SERVICE BULLETIN

Issued: 7/23/24

SUBJECT: NGI-5000 IGNITION TIMING SETUP AND REVIEW

UP TO AND INCLUDING FIRMWARE VERSION 1.3 (date 10-11-23) of the Logic Module Firmware

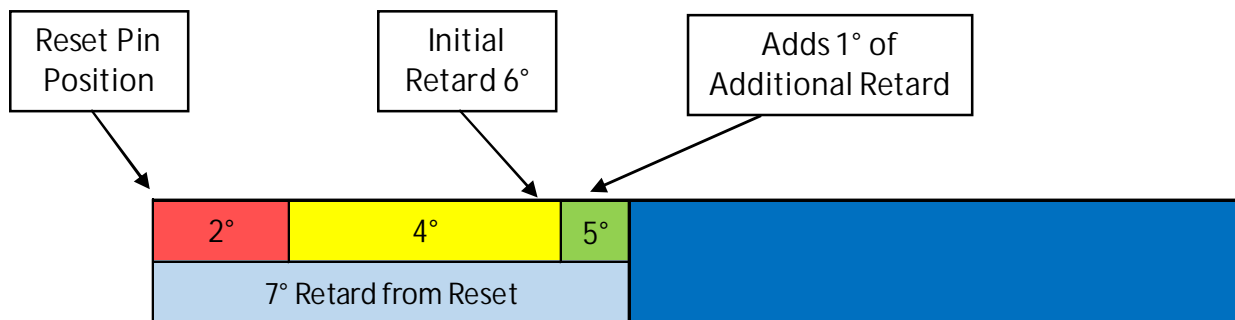
Manual retard timing would start at 0° on the display. When making an adjustment, no change would come into effect until 5° which would add 1° of manual retard. There is insertion retard of 2° plus the reserved 4° for individual retard which is a total of 6°. Therefore, when adding manual retard on the screen 5° will yield an additional 1° making a total of 7°.

VERSION 1.4 (date 1-9-24) of the Logic Module Firmware

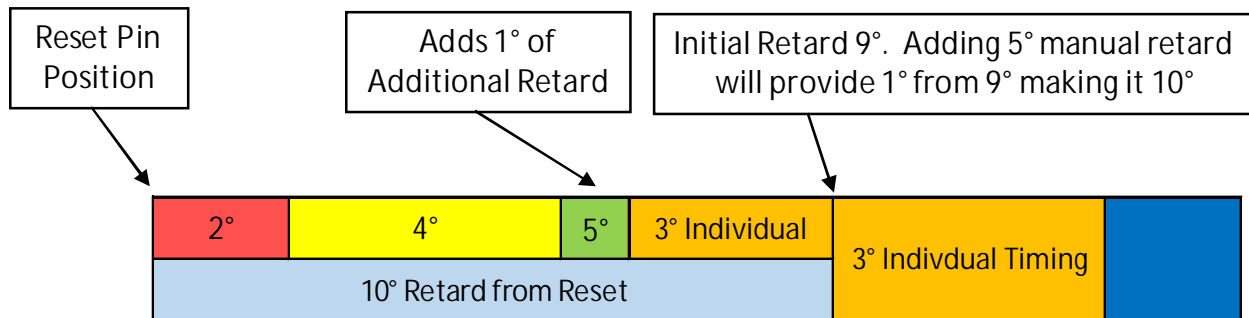
This release added the ability for individual timing which is $3^\circ \pm$. Upon adding this feature, it was appended after the 2° and the reserved 4° . A total of 9° is set as the starting point with no manual retard added. In version 1.4 in order to get the roughly 3° back advanced all of the individual timing must be advanced and will make the achievable retard after the reset 6° .

VERSION 2.0 of the Logic Module Firmware (PENDING RELEASE)

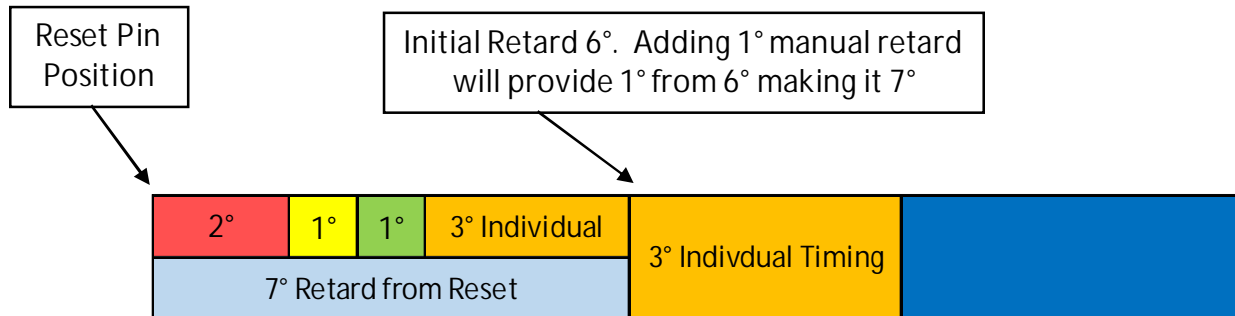
Version 2.0 has not been released but is in test. With regard to timing, the CPU-2000 approach has been restored. There are 6° after the reset standard starting out with no manual retard. The display reads 0 for actual 0° degrees of manual retard. When pressing the button to increase the manual retard to 1° the retard value will be increased by 1 to 7° . Taking the individual retard to -3° will make the timing for that cylinder 3° after the reset. Taking the individual retard to $+3^\circ$ will make the timing for that cylinder 9° after the reset.
